Bid Bulletin #03

PROJECT: Weeping Water Public Schools
Additions & Renovations
Weeping Water, NE

RE: Addendum No. 2 to the Bidding Documents for:
Weeping Water Public Schools
Additions & Renovation
204 West O Street
Weeping Water, Nebraska 68463
Schemmer Project No. 06368.001

This addendum consists of nine 9 pages of written addendum items and thirty-three 33 pages of supplemental drawings.

SHEET NO: SDA-8

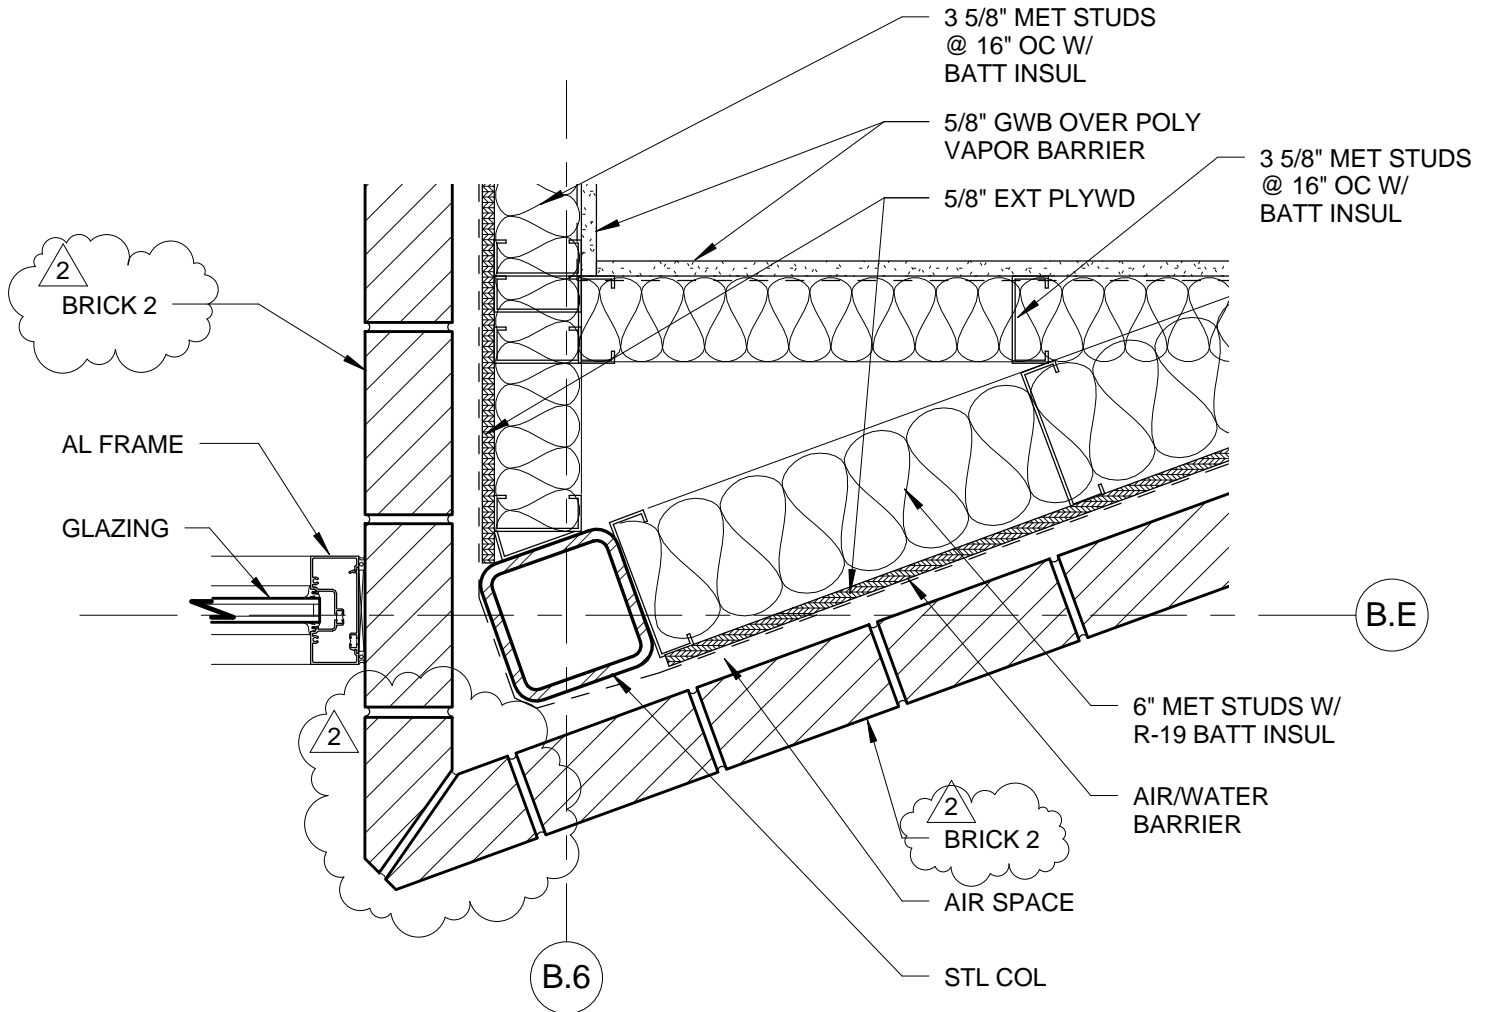
Item No. DA-2, Sheet A1-17

- 1) Detail 4
 - a. REMOVE "BRICK 4", ADD "BRICK 2" in its place.
 - b. REMOVE "FACE BRICK", ADD "BRICK 2" in its place.
 - c. See SDA-8 attached for revisions.

DATE: 02/14/14	DRAWN: MEM	SCALE: As indicated	SHEET NO: SDA-9
SHEET TITLE: DETAIL			REF: A6-08

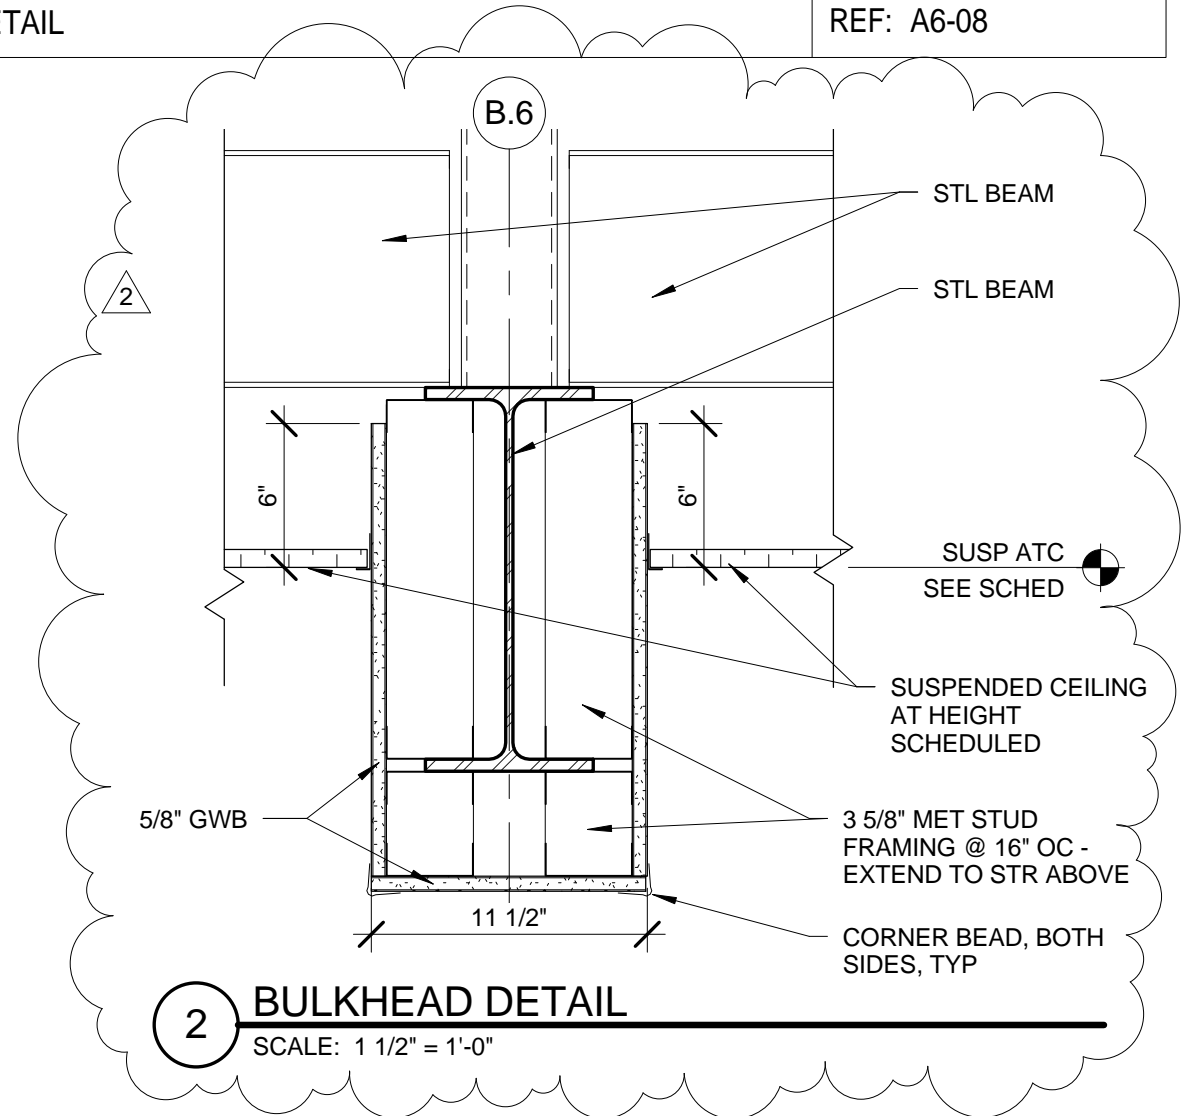
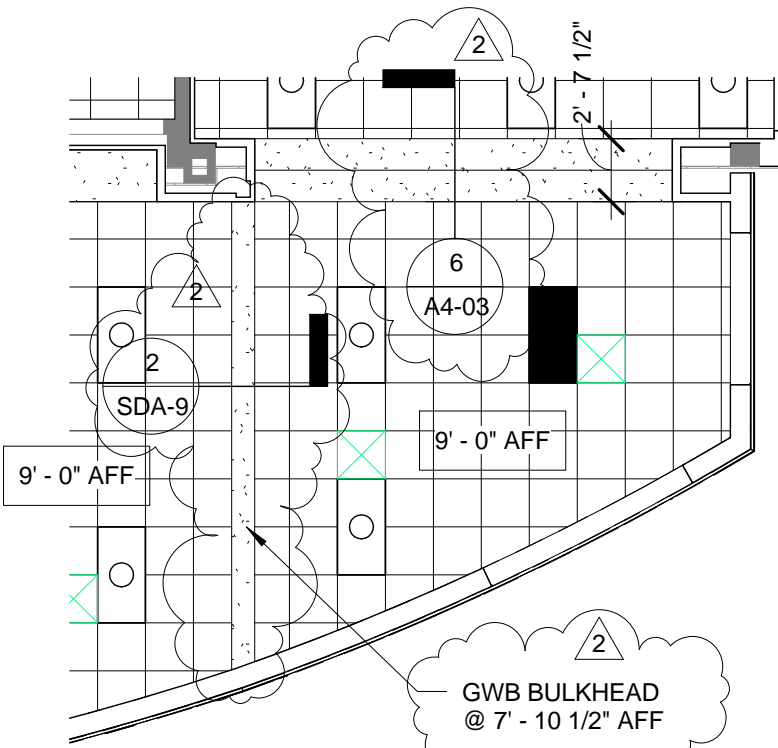
Item No. DA-12, Sheet A6-08

- 1) SECOND FLOOR PLAN – AREA B – REFLECTED CEILING
 - a. See 1/SDA-9 for revisions.
 - b. ADD detail 2/A6-08 on SDA-9.

SHEET NO: SDS-4

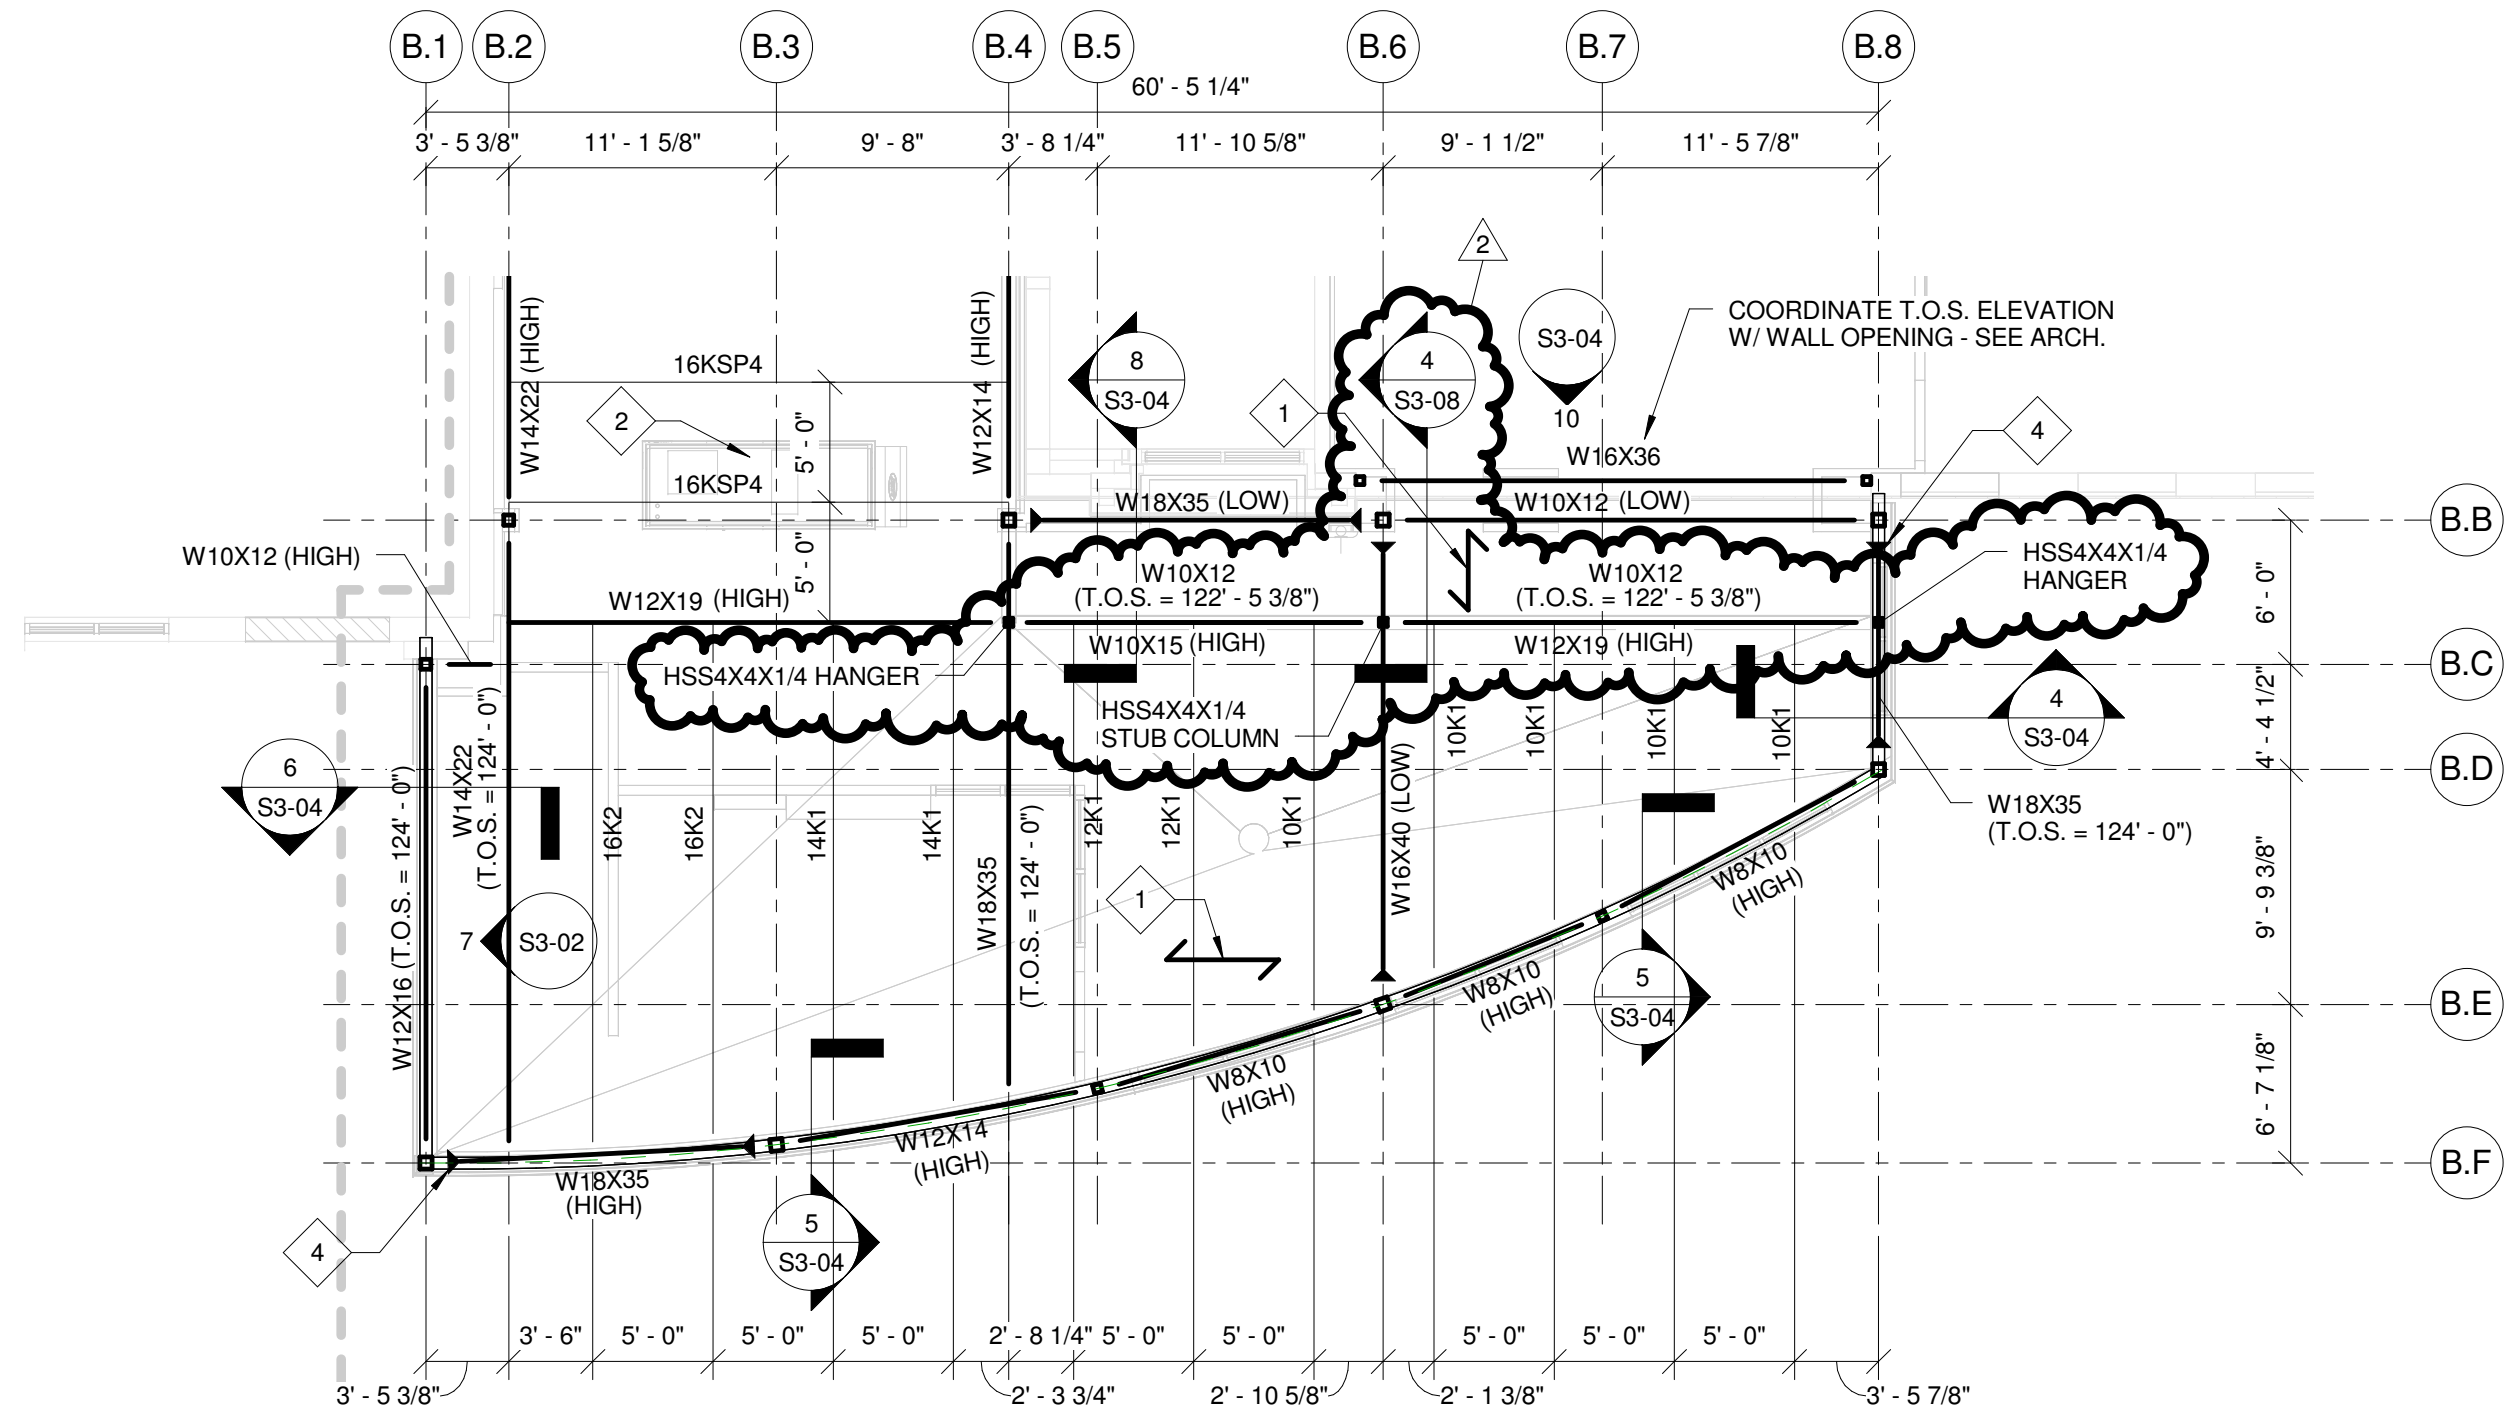
Item No. DS-1, Sheet S1-06

- 1) Area B Roof Framing General Plan Notes, note 'E', DELETE "LOW T.O.S. ELEVATION IS 122'-7 1/2". ADD "LOW T.O.S. ELEVATION IS 121'-7 1/2". in its place.
- 2) Plan 2/S1-06, see attached supplemental drawing SDS-4 for modifications to this plan.

SHEET NO: SDS-5

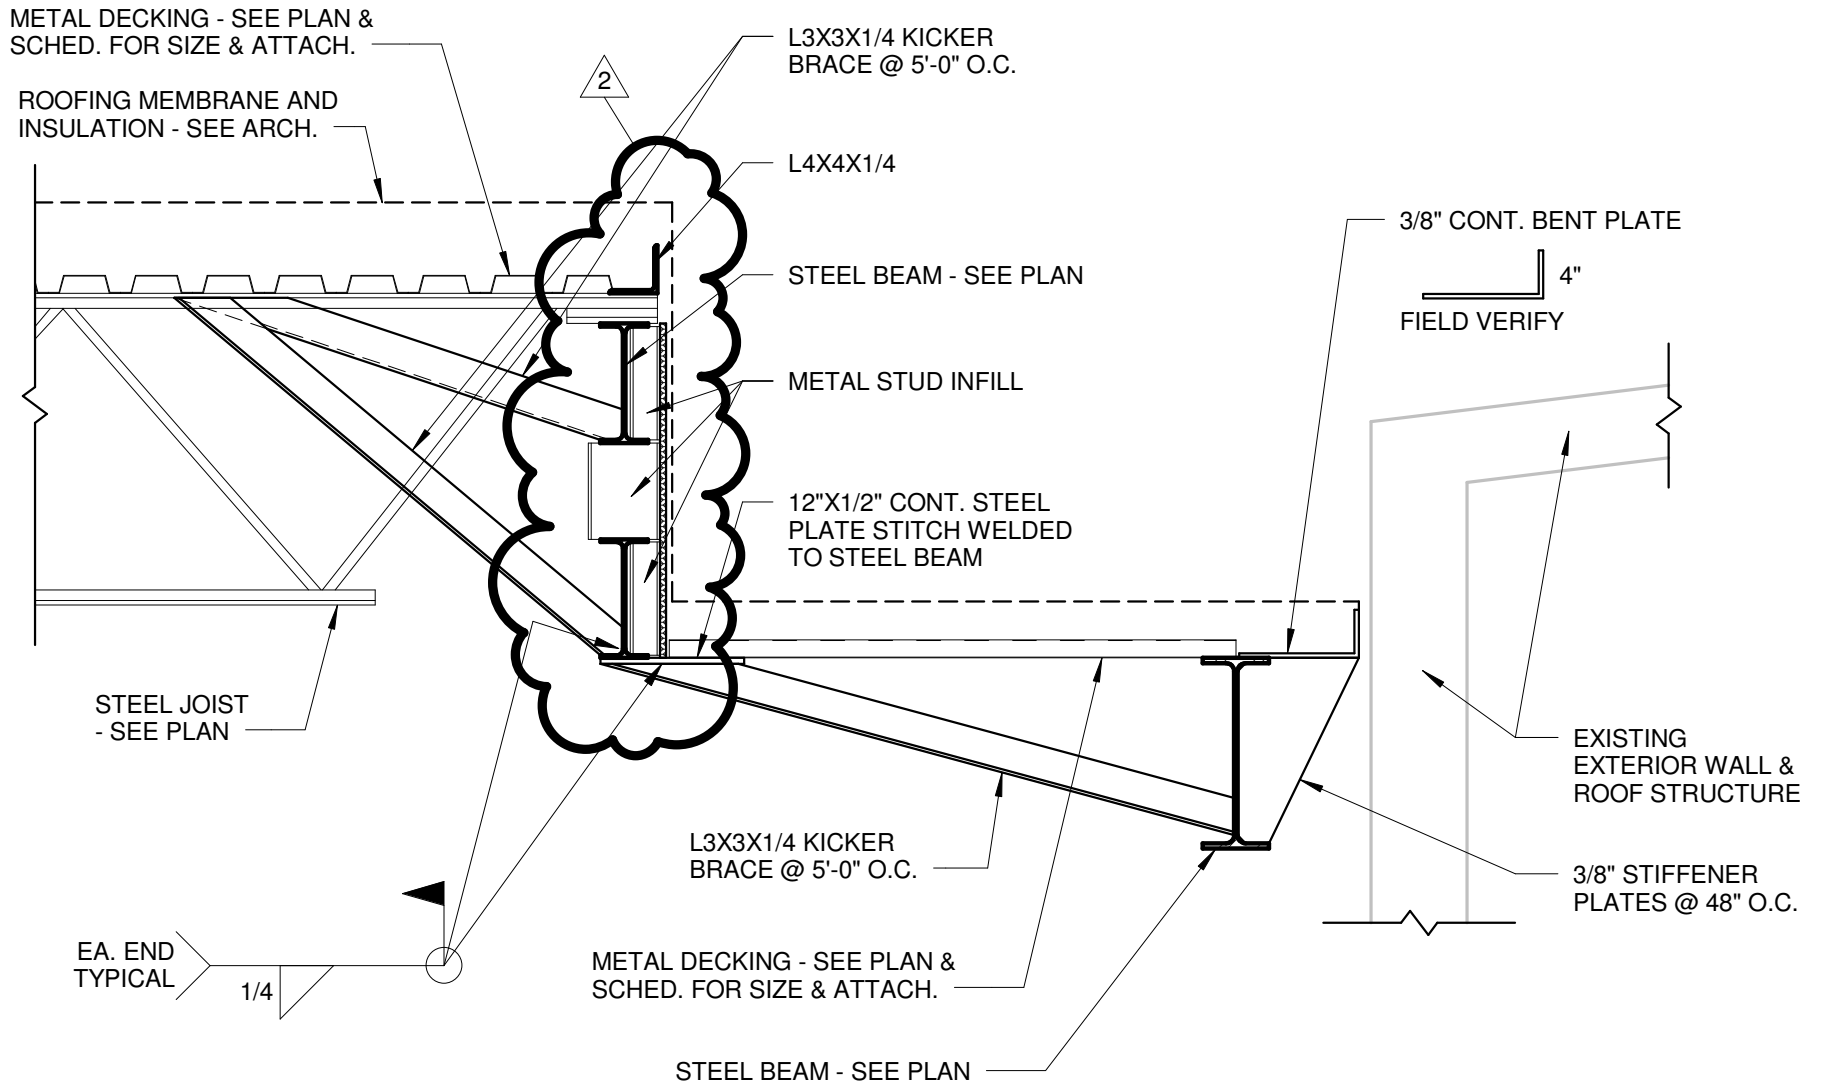
Item No. DS-2, Sheet S3-04

- 1) Detail 8/S3-04, see attached supplemental drawing SDS-5 for modifications to this detail.

SHEET NO: SDS-6

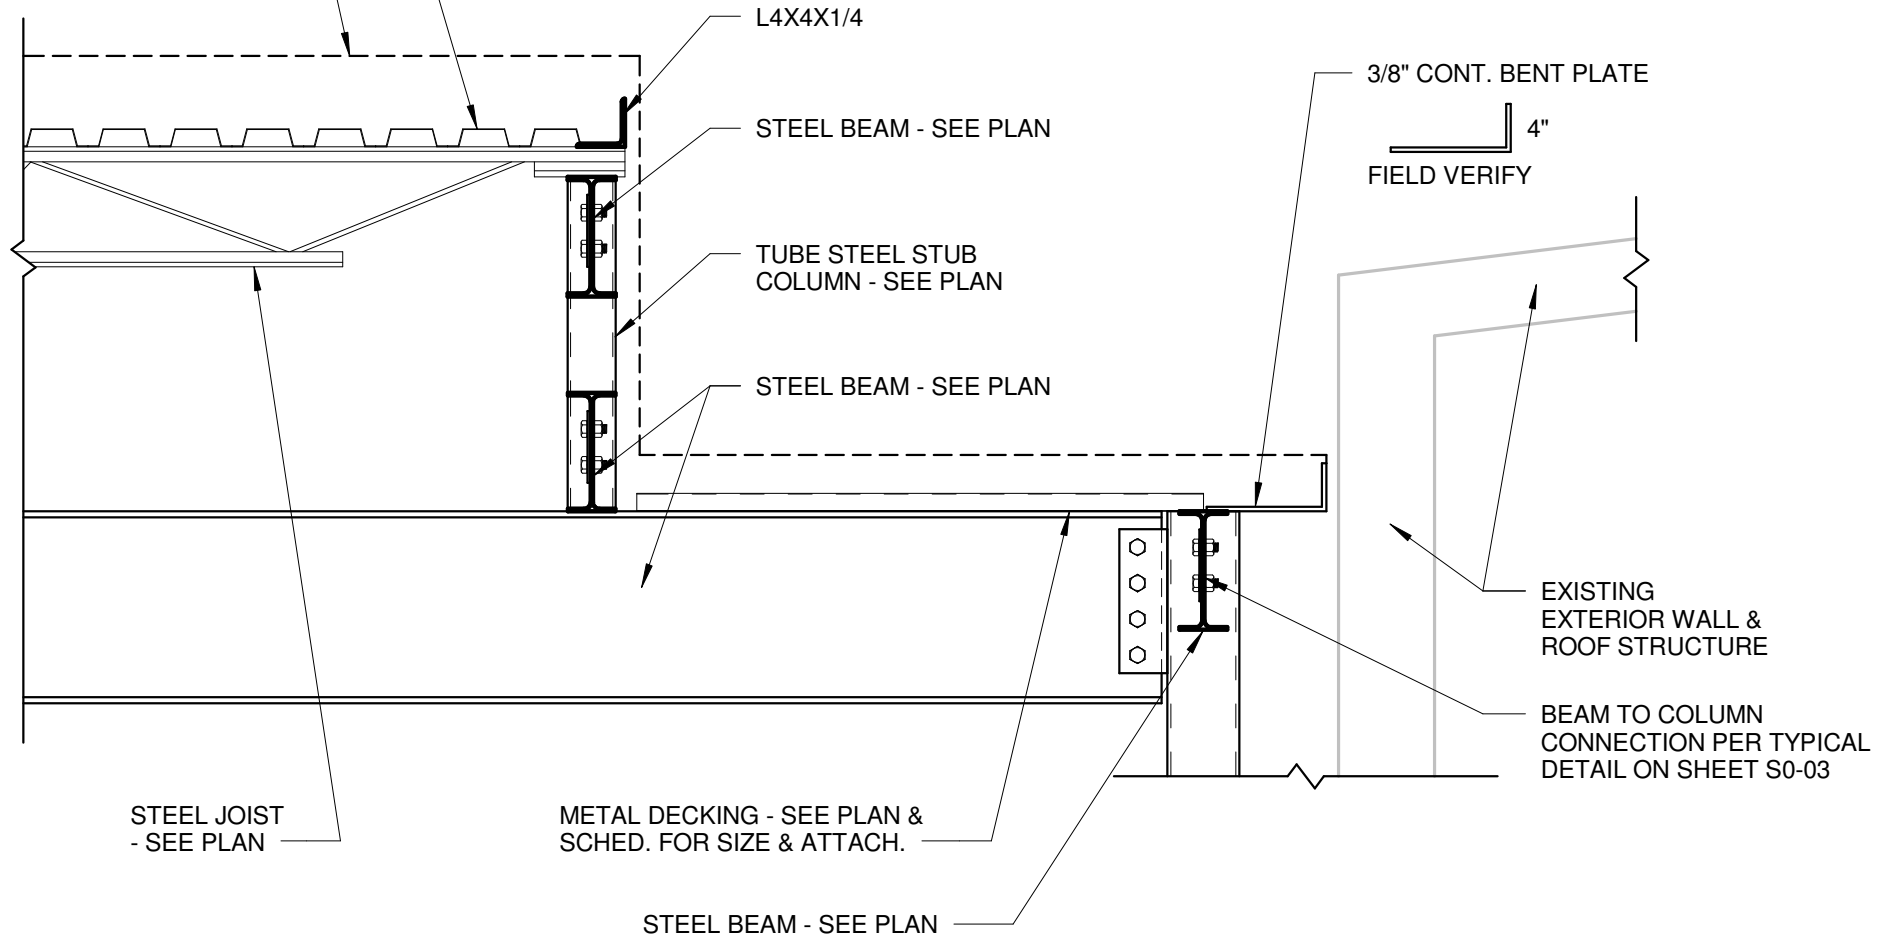
Item No. DS-3, Sheet S3-08

- 1) ADD detail 4/S3-08 as shown on attached supplemental drawing SDS-6.
